SERVICE BULLETIN

Service Bulletin No. 075 Rev. A

Alternator Drive Coupling Inspection

1. This page transmits the revision of Service Bulletin 075 Rev. New to Alert Service Bulletin 075 Rev. A, dated April 17, 2019.
 - A. SB 075 Rev. New, dated September 27, 2018

Figures 1 & 2 - Alignment Inspection

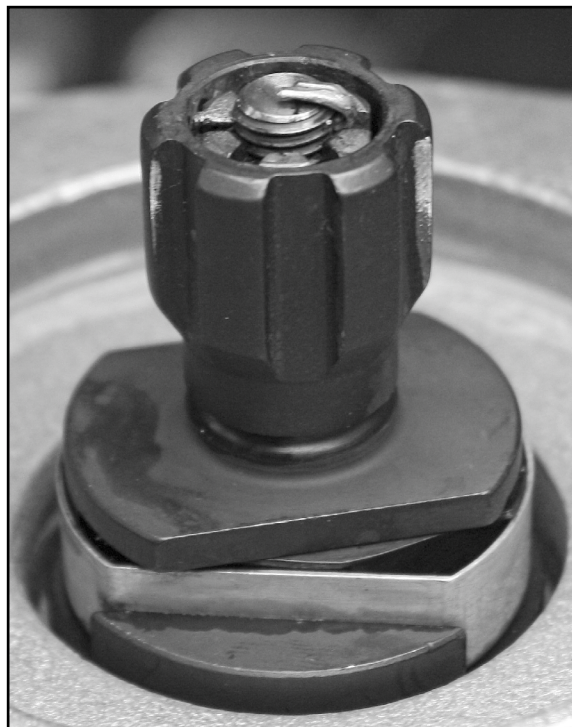
- (3) If the alternator serial number is affected per section 1.A:
 - (a) Utilize applicable aircraft maintenance manual to remove the alternator and inspect the alternator gear drive (Item Number 4, Table 2 – Materials Required) for correct alignment. Refer to Figures 1 & 2 - Alignment Inspection.

- 1) If **INCORRECT** alternator gear drive alignment is observed, continue to Corrective Action section 3.B.(1).
 - 2) If **CORRECT** alignment is observed, the affected alternator may be re-installed on aircraft and re-inspected in accordance with section 3.A.(3) every fifty (50) hours time-in-service until a total of two hundred and fifty (250) hours time-in-service is reached from release date of this SB.

- a) When a total of 250 hours time-in-service is reached from the release date of this SB, continue to Corrective Action section 3.B.(1) of this SB regardless of inspection findings.

Table 2 - Materials Required

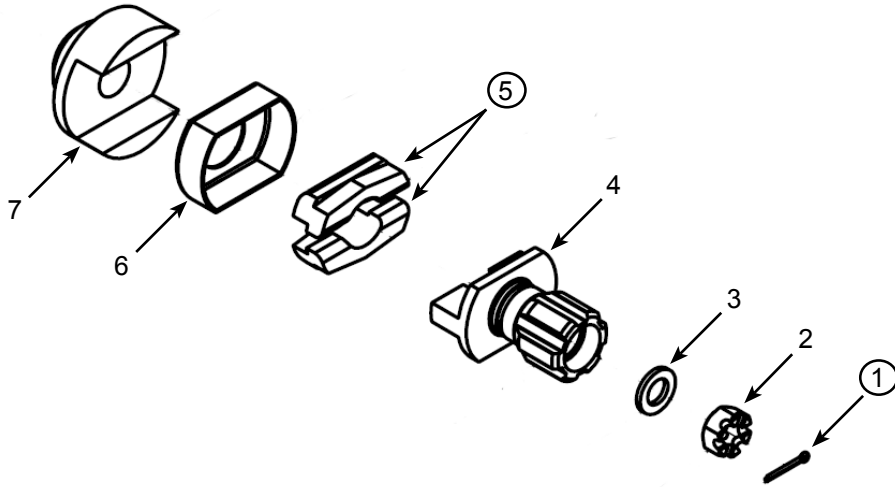
- (3) Add H391B, H-395 (USAF L-28A or U-10B) to Helio Aircraft Model/Series.
 - C. Table 2 - Add NOTE 3:
 - (1) Add reference to JAARS STC SA987SO for alternator P/N 6565 (T, C).

NOTE 3: * If modified IAW JAARS STC SA987SO, refer to same document for materials required with exception of Itm #5 Bushing †, this table.

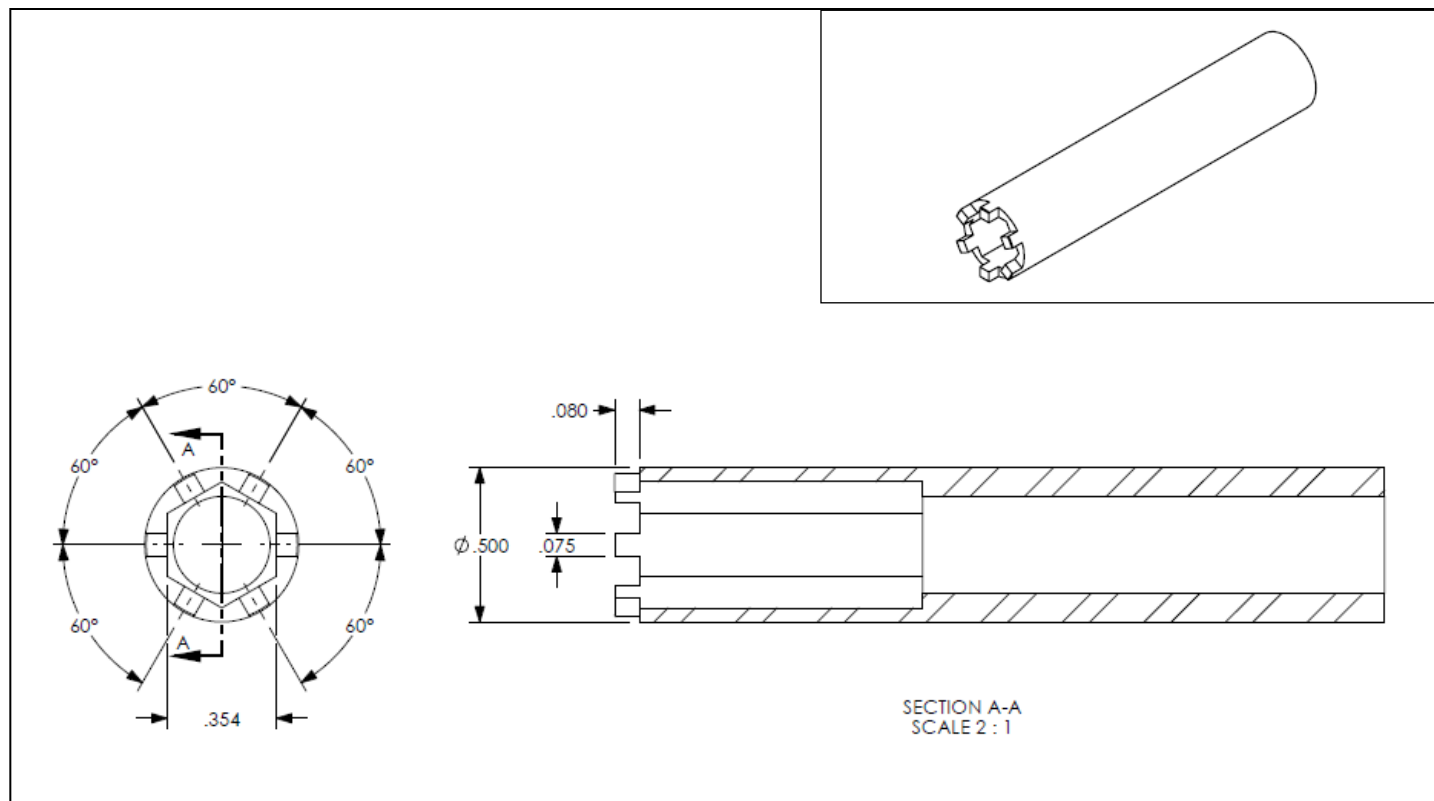
- 1) Remove Cotter Pin (1) from Gear Drive Nut (2) and discard.
- 2) Reference Figure 3 to fabricate a tool that will interface with nut castellations and remove Nut (2) from the gear shaft. Retain nut (2) and washer (3) for assembly.
 - a) Hold base of Drive Gear (4) with a one inch crowfoot wrench or small strap wrench while removing Nut (2).
- 3) Remove Drive Gear (4) from gear shaft and retain for assembly.
- 4) Remove Bushings (5) from Retainer (6) and discard.
- 5) Inspect On-condition (▲) parts for damage. Replace if worn or damaged. *Refer to Item Numbers in Table 2 – Materials Required.*
